MEMORANDUM

Re: Modifications to Design Review approval at approximately 175 North 600 West:
Kozo House Design Review - PLNPCM2020-00258

REQUEST: Bryce Baker, the property owner representative, is requesting modifications to the Kozo House Design Review approval. The project received Design Review approval from the Planning Commission on December 2, 2020 and their approval was extended for one year on November 10, 2021.

KOZO HOUSE

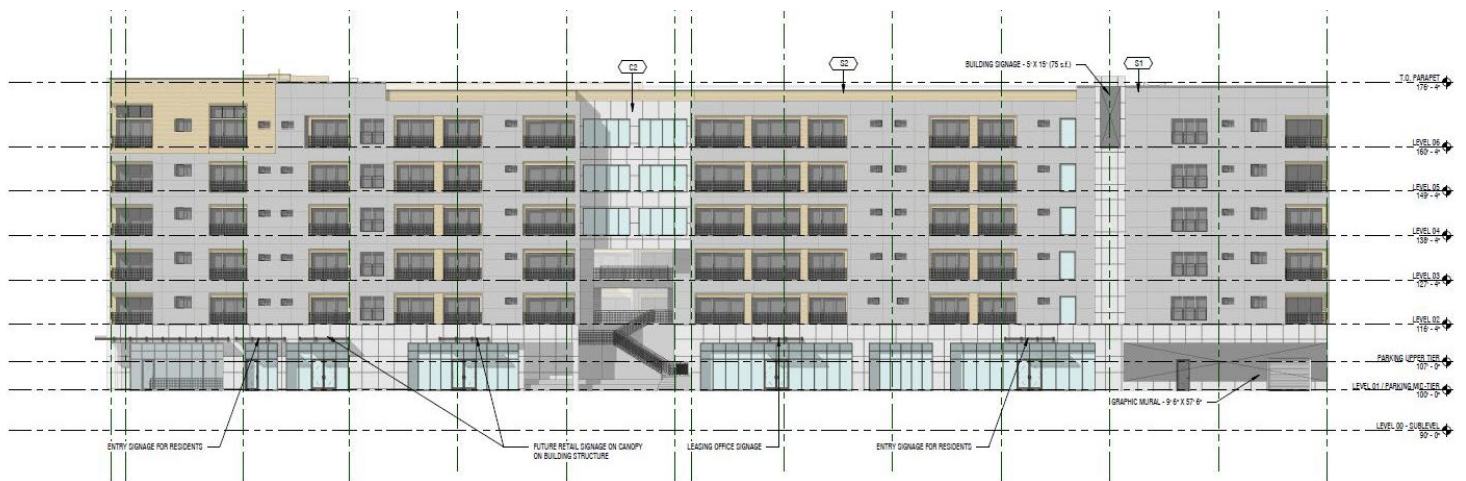
Approved by the Planning Commission: The commission approved 141 parking stalls as part of the original design. The original design provided approximately 0.44 stalls per living unit.

Revised Proposal: The revised amount of provided parking is 190 stalls. Table 21A.44.030 lists the minimum amount of parking required. Generally, multifamily developments are required to provide 2 parking stalls for each residential unit with 2 or more bedrooms, 1 parking stall for each unit with 1 bedroom and 0.5 parking stalls for each studio unit (up to 600 square feet in size). The unit mix in this project would require 214 stalls for the project per these guidelines. Additionally, the project is providing 2,100 square feet of leasing area and 2,730 square feet of retail space. These additional spaces would require 5 parking stalls for the retail area and 6 parking stalls for the office leasing area. In total, the minimum off-street parking requirements would come to 225 stalls. However, because this project is within a TSA zone it is eligible for a reduction of the minimum parking counts by up to 50% which brings the minimum number of stalls down to 113. The proposed number of parking stalls comply with this minimum and does not exceed the maximum of 378 parking stalls as set out in section 21A.44.030 of the city’s adopted ordinances.

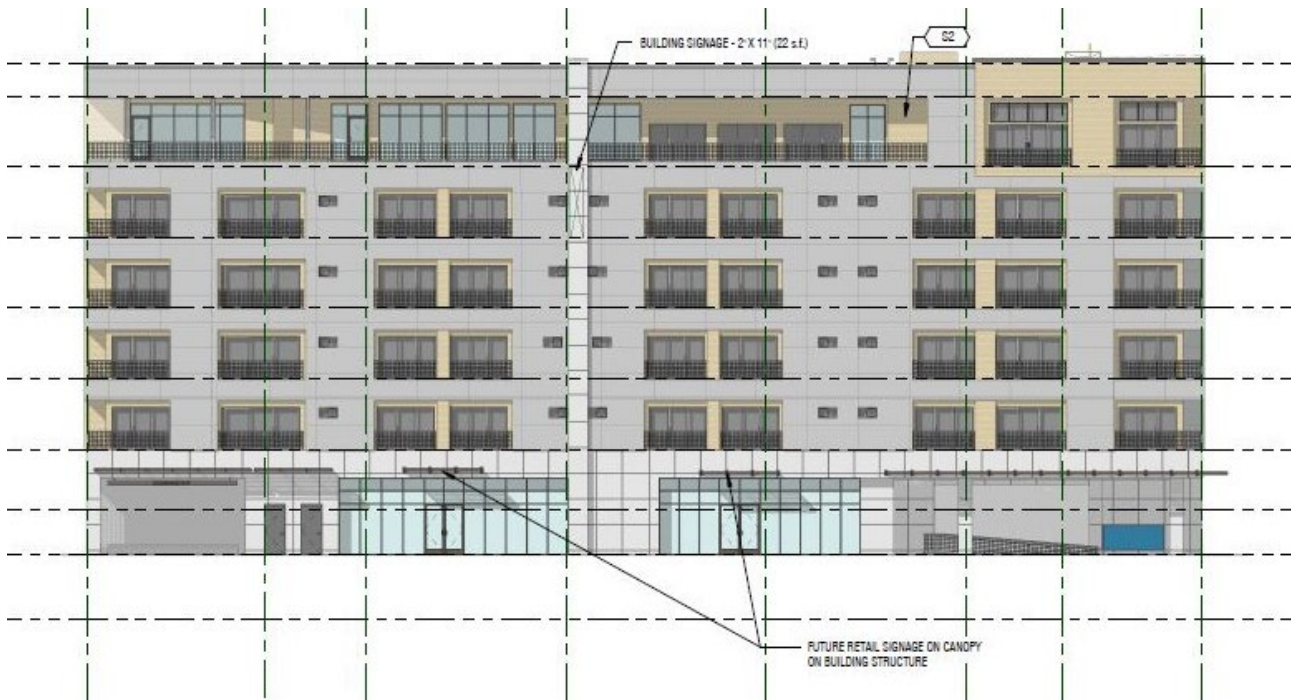
Approved Northern Façade

Updated Northern Façade

Approved Eastern Facade

Updated Eastern Facade

Approved Southern Façade

Updated Southern Façade

Approved Western Façade

Updated Western Façade

Revised Proposal: The design of the facades has changed slightly to accommodate the changes in vehicular access and storefront space. The Applicant has provided calculations showing the ground floor glass in the project has been reduced from 90.5% to 66% on the eastern façade and from 76.4% to 71% on the northern façade. The project is required to provide a minimum of 60% ground floor glass and the revised proposal continues to meet this

requirement. Additionally, screened openings have been added on the ground floor parking garage walls to allow for ventilation. The revised façade designs incorporate the same materials approved in December 2020 but the overall arrangement of the facades has been altered with the revised floorplans.
